June 10, 2005

MEMORANDUM TO TEAM LEADERS AND CONSULTANTS

SUBJECT: Bridge Railing

REINFORCED CONCRETE BRIDGE RAILING
WITH VERTICAL TRAFFIC FACE

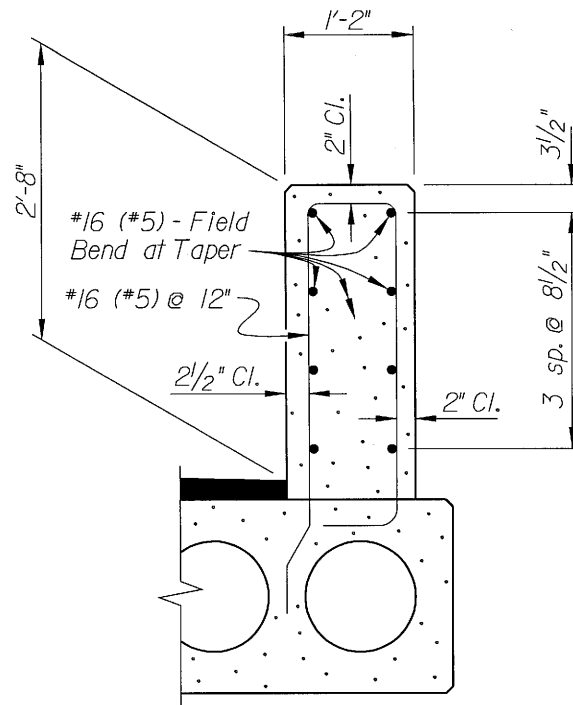
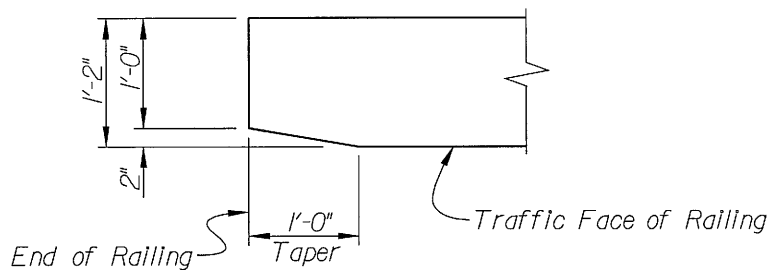
- For bridges less than 50 feet in length and having straight wing walls (wing walls that are parallel to the centerline of bent), a reinforced concrete bridge railing with a vertical traffic face shall be used. See attached Detail.
- For bridges 50 feet or greater in length and for all bridges having parallel wing walls (wing walls that are parallel to the centerline of bridge), the Department's standard barrier parapet and the Department's standard barrier parapet transition shall be used.
